**SB-GA8-2011-73**

## Service Bulletin

Enlarged Rudder Hinge Bushes

Aircraft serial numbers from GA8-00-004 to GA8-TC 320-09-151

**Figure 1 – Rudder Hinges**

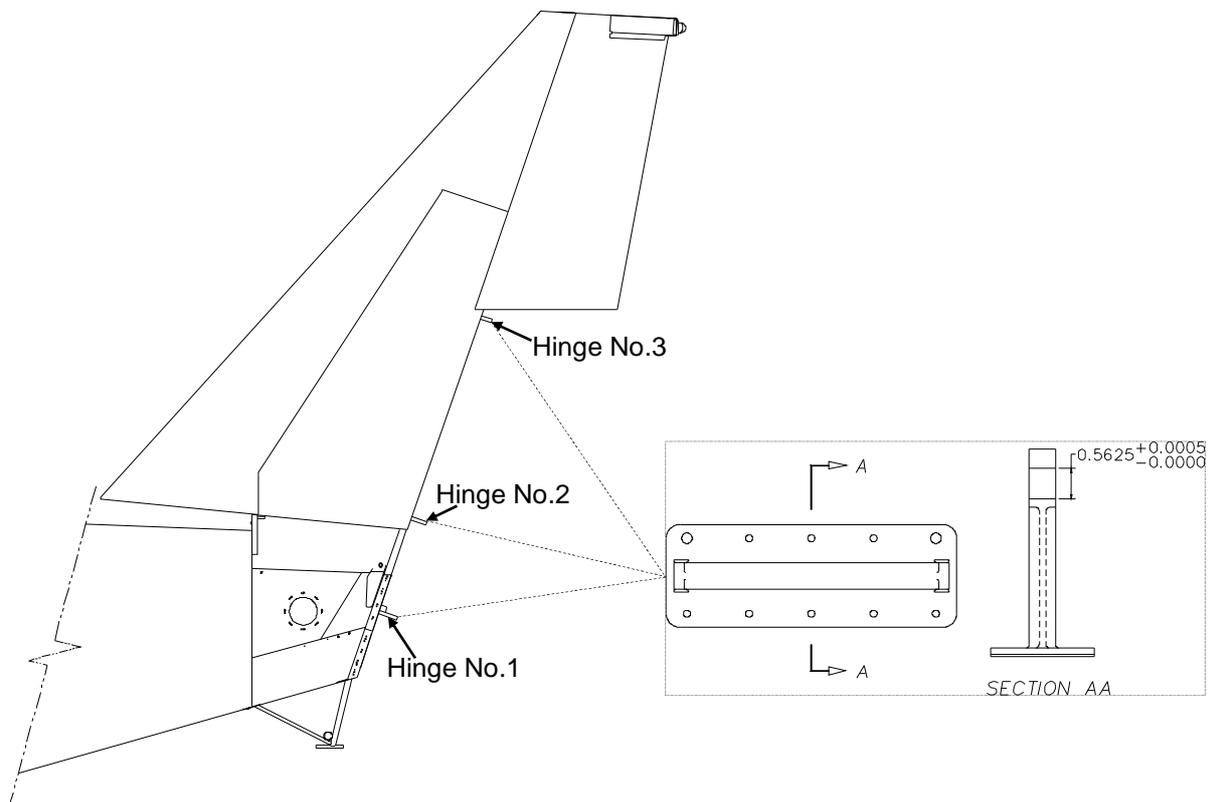
1. Remove the rudder from the aircraft in accordance with the GA8 Service Manual (page 27-10);
2. Remove and discard the three existing rudder hinge bushes;
3. Ream the rudder hinge holes as indicated in Figure 1;

**Figure 2 – Rudder Hinges Bushes and Sleeves – Exploded View**

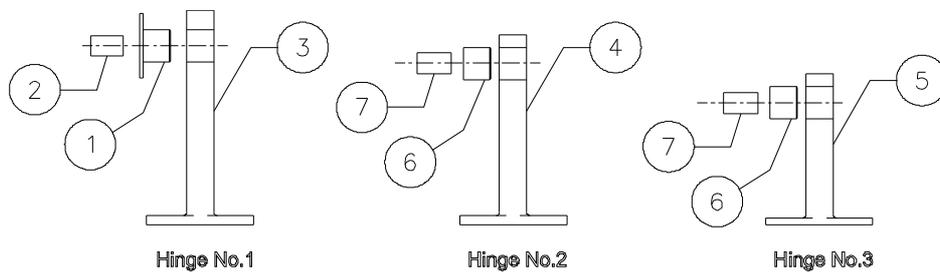
4. Install the bush - P/N GA8-553021-275 (1) and sleeve P/N GA8-553021-277 (2) to the rudder hinge (3). Refer to Figure 2;
5. Install the bush – P/N GA8-553021-279 (6) and sleeve P/N GA8-553021-281 (7) to the rudder hinge (4). Refer to Figure 2;
6. Install the bush – P/N GA8-553021-279 (6) and sleeve P/N GA8-553021-281 (7) to the rudder hinge (5). Refer to Figure 2;
7. Reinstall the rudder in accordance with the GA8 Service Manual (page 27-10) discarding one of the existing washers AN970-4, part of Hinge No.1 attachment.
